# Access Compliance Report

## Public Rights-of-Way

### (Curb Ramps)

Intersection ID: 10024956	Main Street: DISTRICT_SOUTH_DR	Cross Street: N/A	Location:	N
ADA ID: EA8768B68A45	Ramp Type: Perp	Initial Pass/Fail: Fail	Overall Compliance: No	Severity Score: 12.5
Codes/Mitigation Info/Possible Solution		Field Measurements/Component Compliance

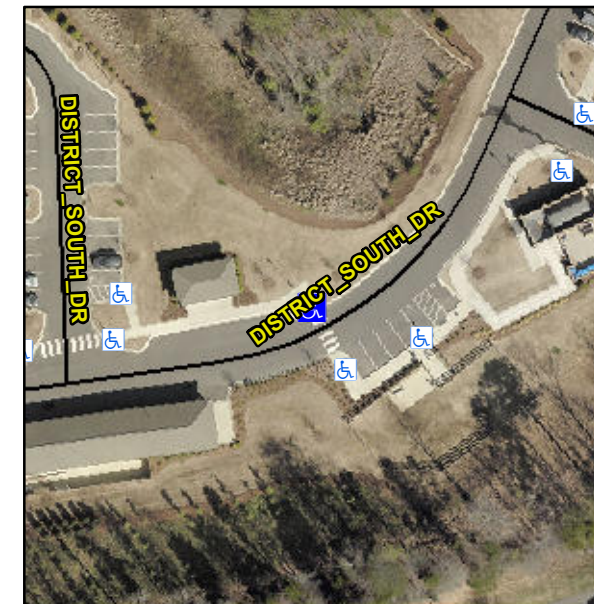
**Not Found, R304.5.3**

Compliance	Description	Data	Compliance	Description	Data
N/A	Ramp Length (in)	69.0	Yes	Ramp Slope (%)	6.7
Yes	Ramp Width (in)	59.0	No	Ramp XSlope (%)	5.5
N/A	Flare Type LT	N/A	N/A	Flare Type RT	N/A
N/A	Flare Slope LT (%)	N/A	N/A	Flare Slope RT (%)	N/A
N/A	Flare Traversable LT?	N/A	N/A	Flare Traversable RT?	N/A
N/A	Landing Length (in)	N/A	N/A	DWS Provided?	N/A
N/A	Landing Width (in)	N/A	N/A	DWS Contrast?	N/A
N/A	Landing Slope (%)	N/A	N/A	DWS Length (in)	N/A
N/A	Landing X Slope (%)	N/A	N/A	DWS Full Width?	N/A
N/A	Landing Curb? (Y/N)	N/A	N/A	DWS Offset (in)	N/A
N/A	Shared Landing?	N/A			
N/A	Gutter Ponding?	N/A	N/A	Gutter Slope (%)	N/A
N/A	Gutter Lip Ht (in)	N/A	N/A	Gutter X Slope (%)	N/A
N/A	Painted X Walk1?	Yes	N/A	Painted X Walk2?	N/A
	X Walk 1 Direction	To S		X Walk 2 Direction	N/A
N/A	X Walk 1 Width (in)	91.0	N/A	X Walk 2 Width (in)	N/A
	X Walk 1 Slope (%)	1.8		X Walk 2 Slope (%)	N/A
	X Walk 1 X Slope (%)	0.7		X Walk 2 X Slope (%)	N/A

**Remove & Replace Entire Ramp.**
